**SERVICE INFORMATION**

Bulletin Nbr: 811-2236

**Soft top cannot be operated**

Saab 9-3 CV M98 - M00 up to and including VIN Y7000913.

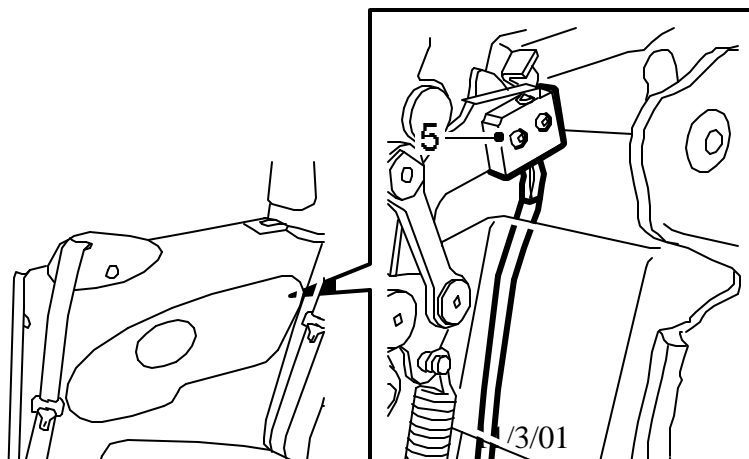
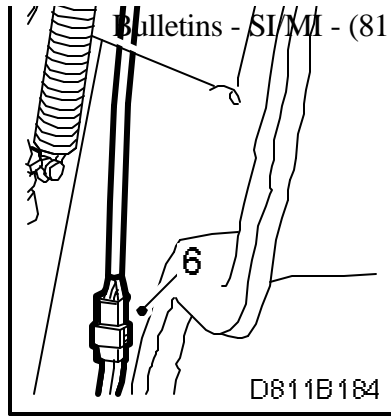
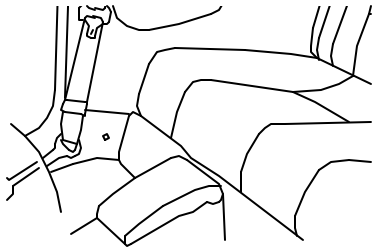
The microswitches for the soft top cover latches can cause functional disorders and therefore have been replaced in production with microswitches of higher quality.

The soft top cannot be operated or it stops in mid-operation. SID displays the message CHECK SOFT TOP COVER and the following diagnostic trouble codes may be generated: B2025, B2026, B2030, B2031.

1. Remove the rear side trim. See "Body - Convertible - Adjustment/replacement - Rear side trim".
2. Remove the clip for the rear trim and lift up the trim.
3. Remove the screws holding the microswitch.
4. Unplug the connector and remove the microswitch.
5. Run the cable through the bracket for the backrest catch mechanism and fit the microswitch.
